DOW TRIGA RESEARCH REACTOR

LICENSE R-108

DOCKET NO. 50-264

SUPPLEMENTARY INFORMATION

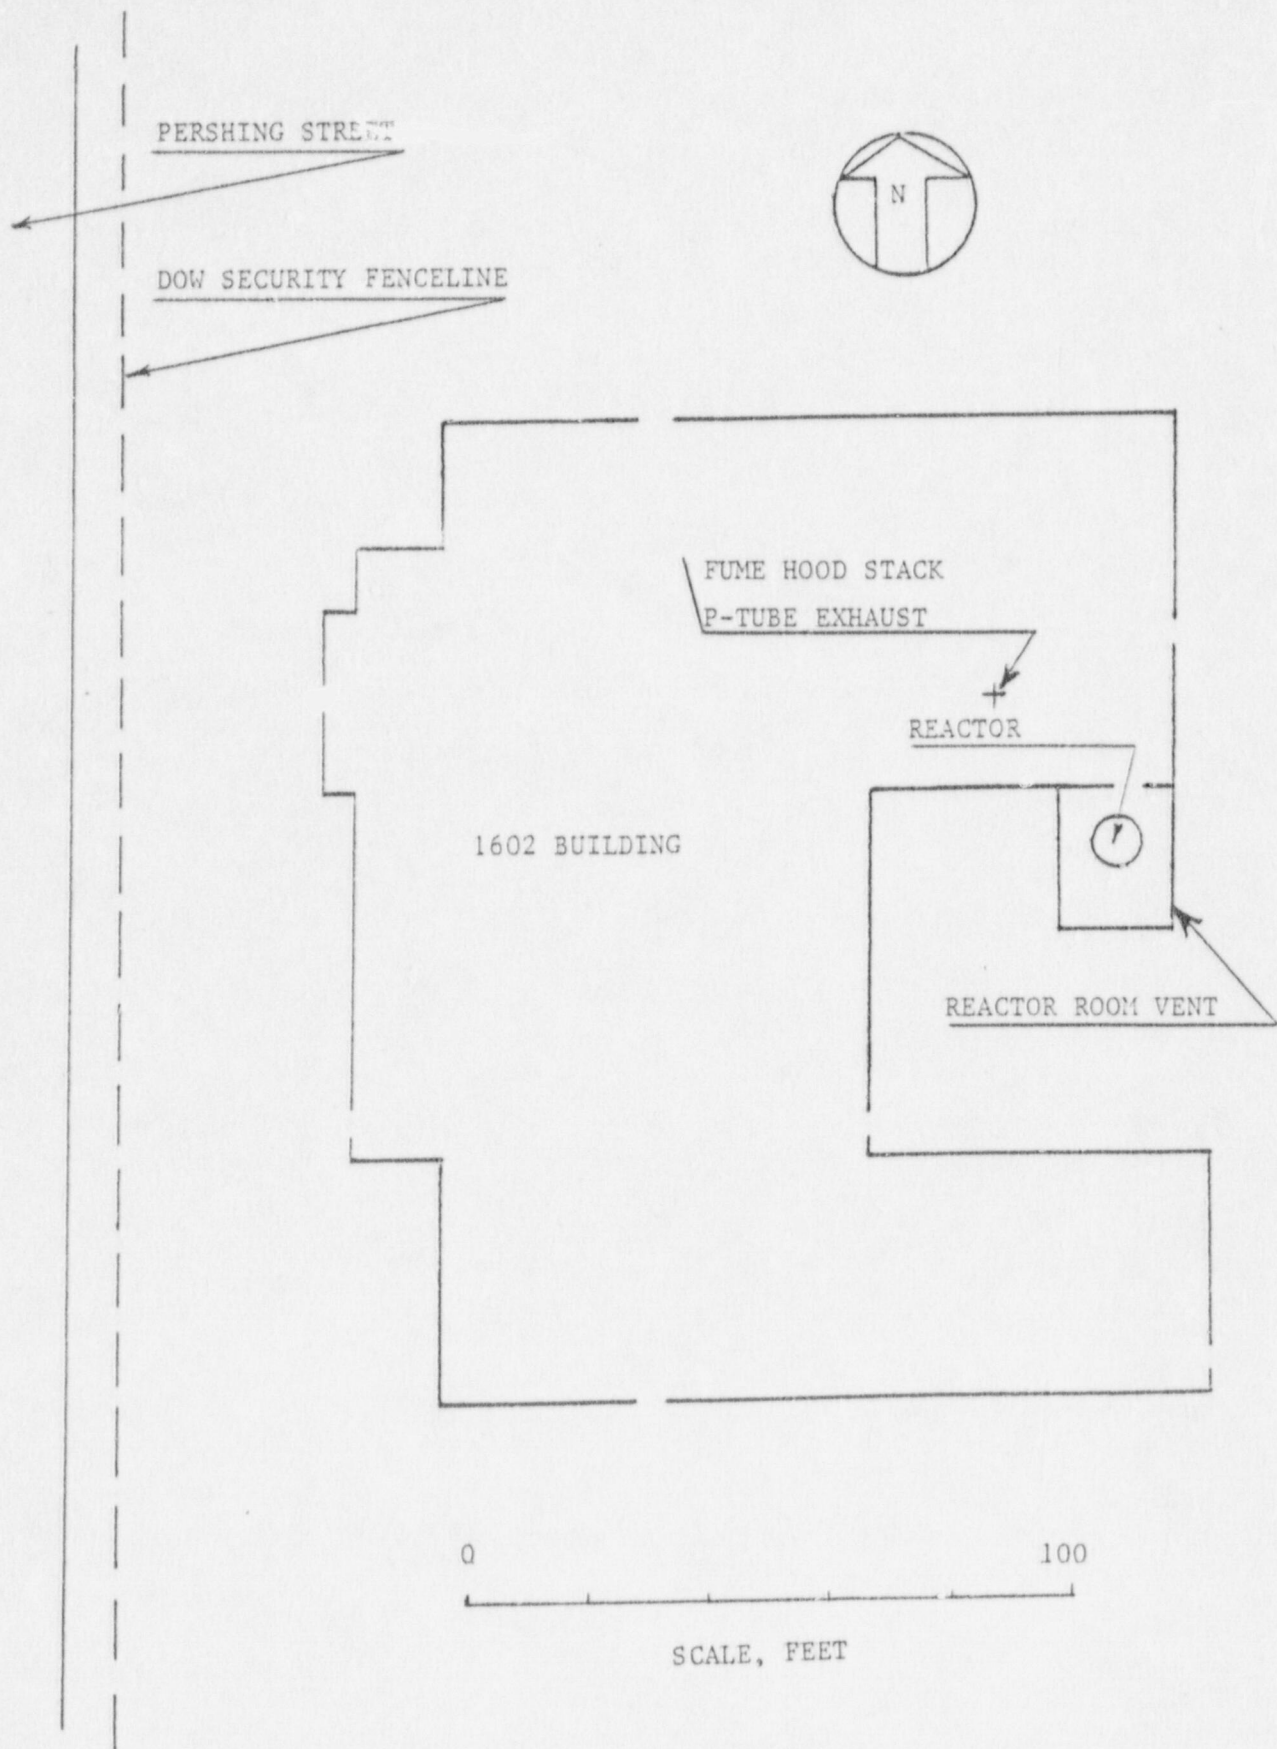
5. Please provide a copy of the diagram showing the relationship between the reactor room and areas of unrestricted access, adding scaling information and indicating the points of release (question 13 of the May 1987 submittal).
